SUBDIVISION COMMITTEE
METROPOLITAN AREA PLANNING COMMISSION

STAFF REPORT
(Final Plat)

CASE NUMBER: S/D 92-22 - BIRKLE ADDITION

VICINITY MAP:

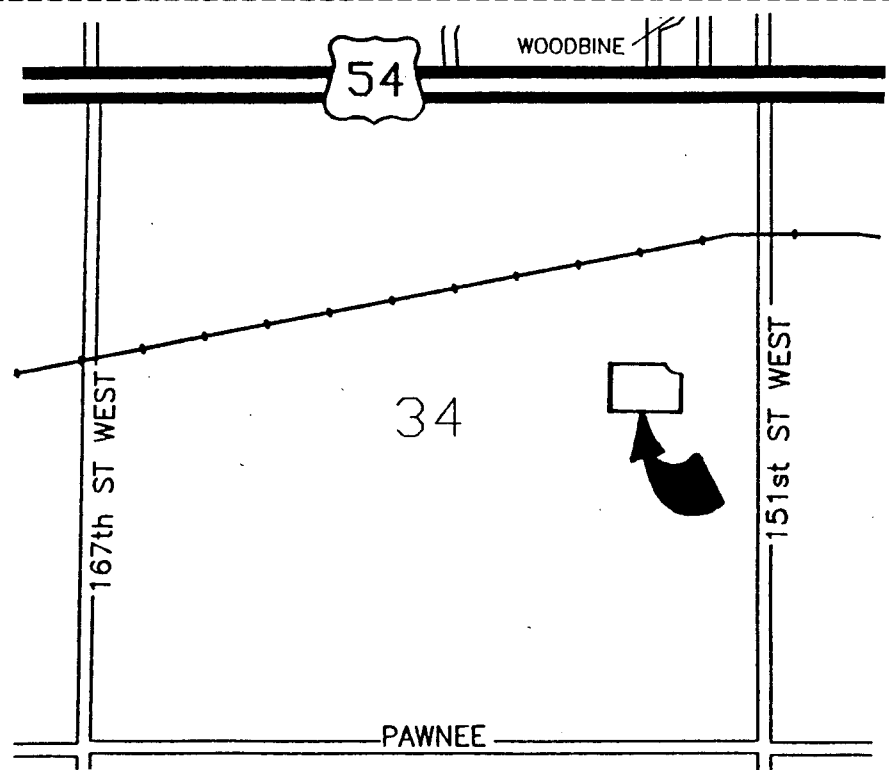
C. As indicated by the map, a public street, Dora Circle, was dedicated and guaranteed with the Jeffery Addition plat. However, Dora Circle does not appear to have been constructed even as far as to the east line of the Jeffery Addition and likely not to present day standards for the portion extending westward from 1st Street West. County Engineering should therefore be prepared to indicate any required guarantees or other requirements needed for Dora Circle. That is, if a guarantee should be provided by this plat and if additional right-of-way is needed.

D. In regard to right-of-way for Dora Circle, this plat shall dedicate additional right-of-way along the entirety of its north line. Unless Dora Circle is extended westward, a substantial area to the west and north will become landlocked. As with the Jeffery Addition, this dedication could or should be created by extending the boundary of this plat to provide for such a dedication. Or if necessary, a dedication by separate instrument may be acquired.
